Disability Access Report

Trinity Point

For: Johnson Property Group
Ref: LP_21398

Concept development application documentation for the Trinity Point Mixed Use Development located at Trinity Point Drive Morisset Park, has been reviewed against current accessibility legislation.

Figure 3 | Overall Site Plan

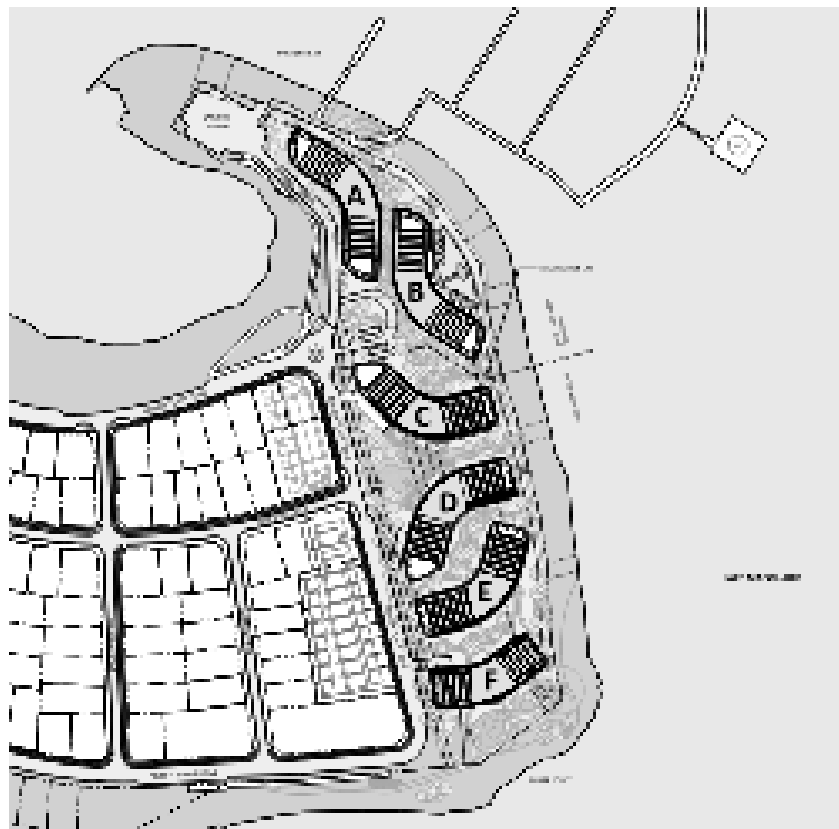
The BCA requires that a continuous accessible path of travel be provided from the allotment boundary at the main points of pedestrian entry to the main entrance.

Compliant in Principle

The landscape strategy identifies major pedestrian linkages and secondary pedestrian linkages. The major pedestrian linkages provide access from the allotment boundaries along Trinity Point Drive and the Foreshore to buildings entrances and recreational activities within the site. The secondary pedestrian linkages are internal to the site and provide a connection to the foreshore.

Figure 7 | Concept Impression Render

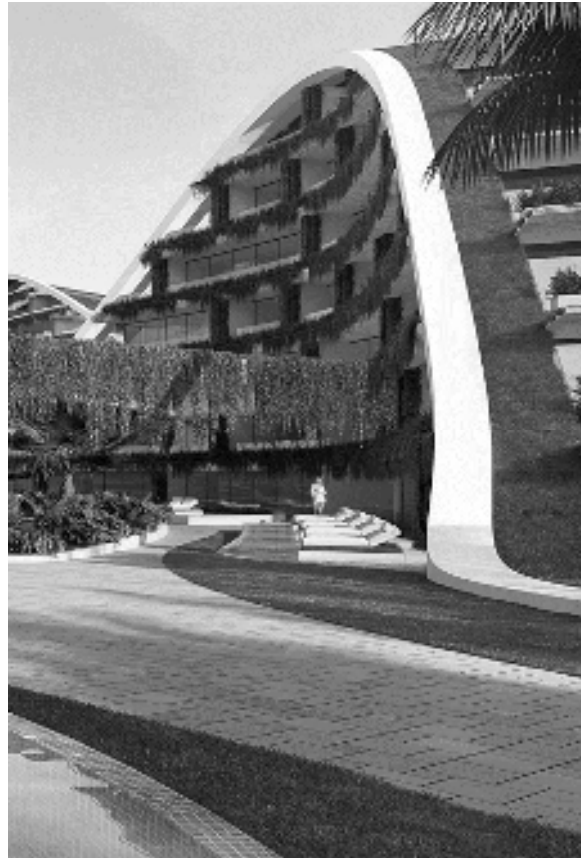
Compliant in Principle

Buildings C, D, E & F are considered capable of compliance with current accessibility legislation as follows:

- There is a pedestrian connection to Trinity Point Drive
- Ease access is afforded at the ground floor level
- Lift cores are distributed evenly within each building and provide access through all levels including basement carparking.
- Direct and clear circulation areas are provided throughout each building
- The design, in its conceptual form, enables flexibility for the provision of adaptable and universal (livable) housing principles.
- Accessible connections are available to the foreshore from the ground floor level private common areas.
